Entergy Nuclear Operations, Inc.
1340 Echelon Parkway
Jackson, MS 39213
Tel 601-368-5573

NL-20-033

Subject: Technical Specifications Proposed Change – Permanently Defueled Technical Specifications

Indian Point Nuclear Generating Station Unit No. 3
NRC Docket No. 50-286
Renewed Facility Operating License No. DPR-64

Figure 3.7.16-1 (Page 1 of 1)

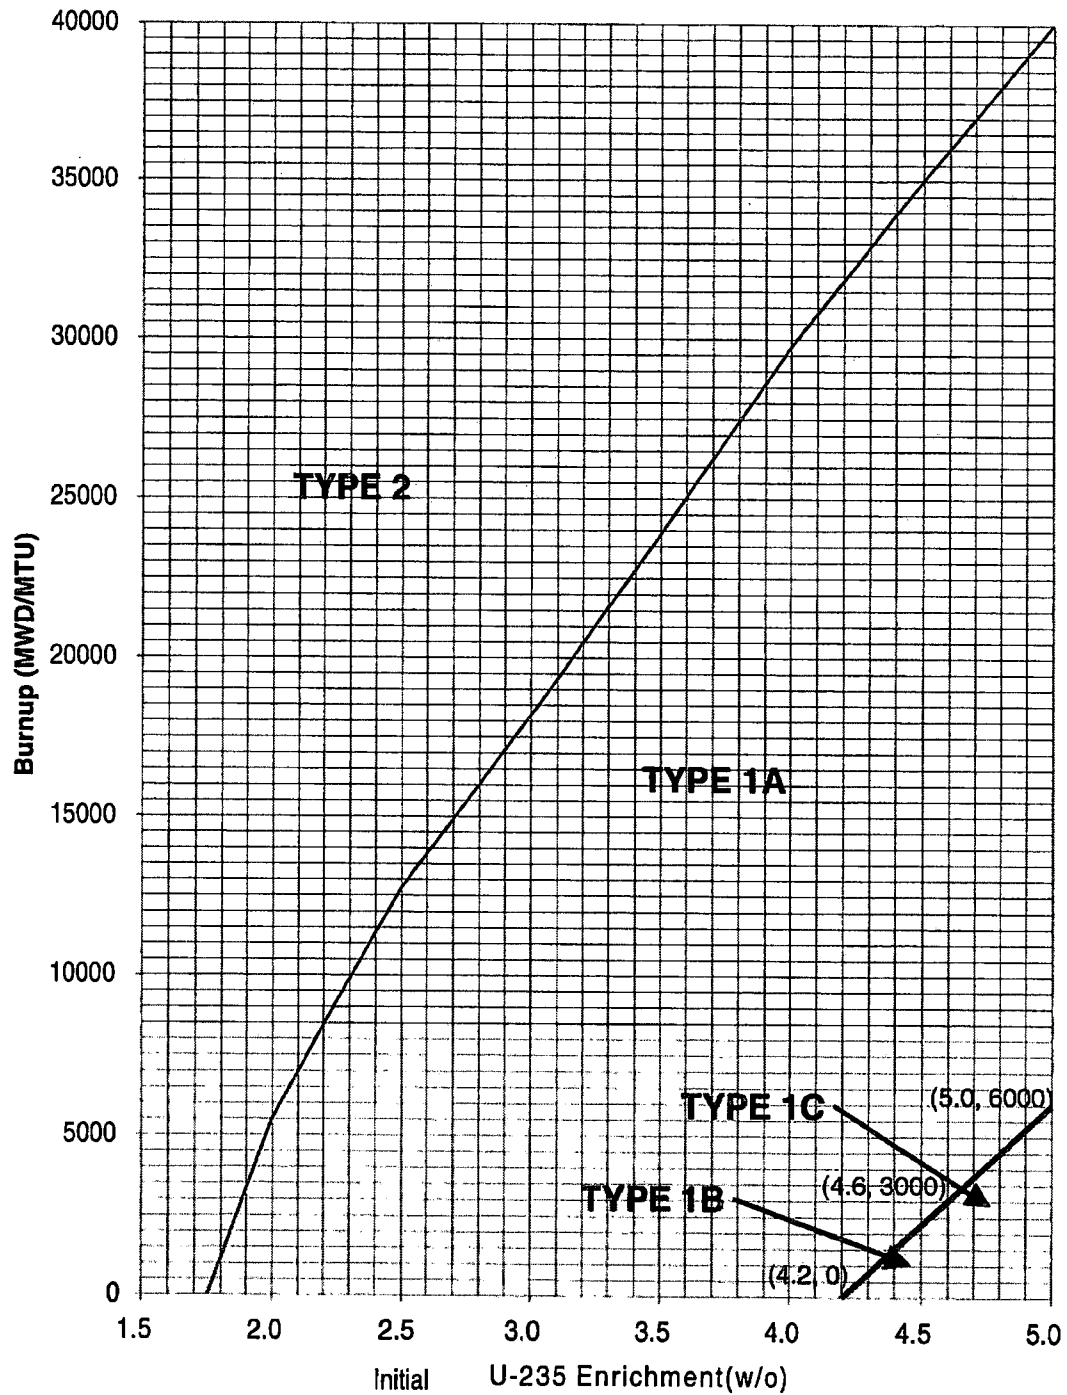
TS 3.7.16, Spent Fuel Assembly Storage	Technical Specification 3.7.16, including Figure 3.7.16-1, is retained in the PDTs. The title of TS Section 3.7 is administratively changed from addressing "plant systems" to addressing "spent fuel pit requirements" to comport with the remaining PDTs Section 3.7 LCOs. In addition, the NOTE in Required Action A.1 (LCO 3.0.3 is not applicable) is proposed to be deleted to conform to the deletion of TS LCO 3.0.3 as previously proposed.
TS 3.7.17, Secondary Specific Activity	<p>Technical Specification 3.7.17 is proposed for deletion.</p> <p>Technical Specification 3.7.17 is applicable in MODES 1 through 4.</p> <p>After the certifications required by 10 CFR 50.82(a)(1) are docketed for IP3, the 10 CFR Part 50 license will no longer authorize operation of the reactor or placement or retention of fuel in the reactor vessel in accordance with 10 CFR 50.82(a)(2). Thus, operation in MODES 1 through 4 will no longer occur. As a result, this TS will not be applicable in a permanently defueled condition.</p>
